LA3215C - Request-for-Tenders under Open (OJEU) Procedure for the Supply, Delivery, Installation and Commissioning of a Suite of Plasma Etcher & Plasma Deposition Tools, [4 Lots] for Tyndall National Institute, University College Cork (UCC)

Tyndall Sub-Fab etch & PECVD vacuum-pumps A.png

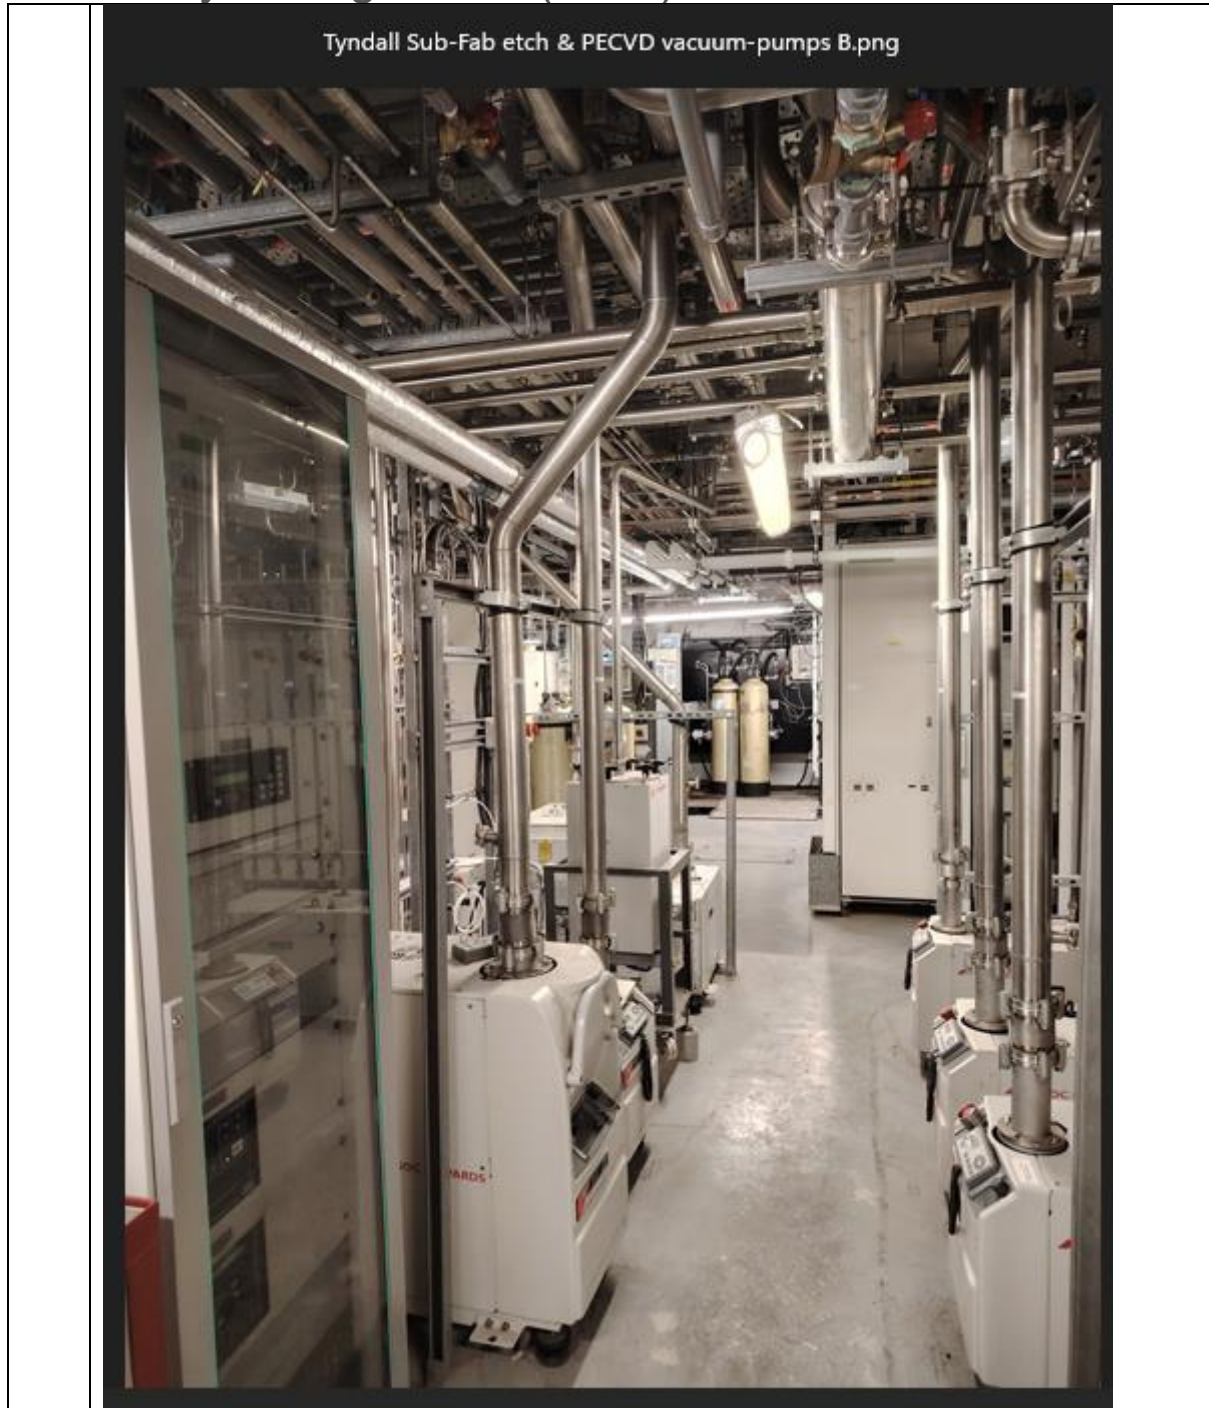
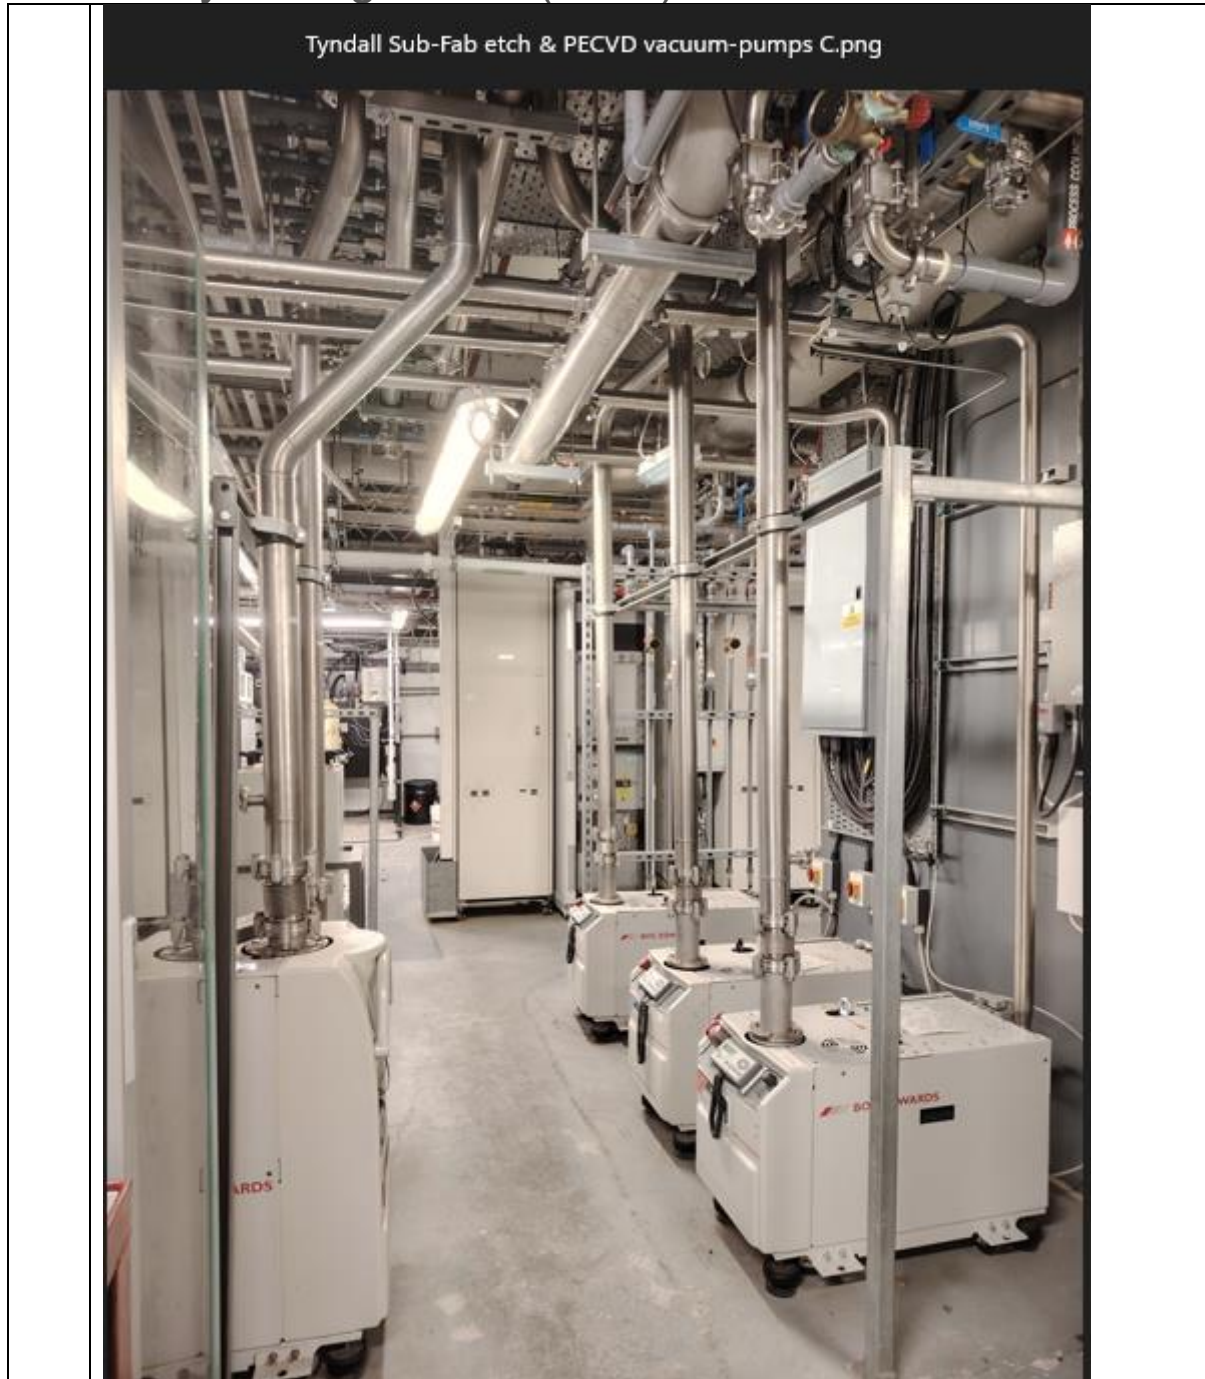
<p><b>Q12</b></p>	<p><b>thanks for the answer.</b></p> <p><b>I can understand the pump and the system are located at different floor and there will be distance in-between. I would like to understand how pipe between the pump and the system is connected, will it has turns? Normally each of the turn will sacrifice 20 percents of the pump efficiency, understanding how the pipeline is arranged will us to configured the right pump.</b></p> <p><b>besides, I see the machine should fit within 5 m2, i would also like to understand is there any requirement of the length and the weight?</b></p>
<p><b>A12</b></p>	<p><i>The vacuum pumps will be located in the Sub-Fab area on a separate floor underneath the cleanroom. The pump lines will have a maximum of 2x right-angle (90°) turns or 1x right-angle + 1x oblique (&lt; 90°) turns; these are typically located directly above the pump itself and directly underneath the through-floor connection to the tool location at Sub-Fab ceiling-level, as the pumps may not sit directly underneath the tool itself. Please see attached photos of the Sub-Fab configuration for reference. Also, please note that as-per specifications A33 / A37, options of other vacuum pumps (which can include models with higher pump capacity than the base model recommended to meet the requirements of specification A32 / A36) should be provided by the Tenderers.</i></p> <p><i>As-per Appendix A, all four tools must fit within the 20 m<sup>2</sup> area highlighted (red box), with approximately 5 m<sup>2</sup> per-tool. Because of the necessity for thru-wall configuration, a maximum length of 2.5 m is preferred to allow for maintenance access directly behind the tool in the service chase.</i></p>

*In relation to weight requirements, it is preferred that the maximum weight is < 2 metric tons per-tool, but this will be assessed on a case-by-case basis by a structural engineer for Tyndall / UCC.*

**See additional images below.**
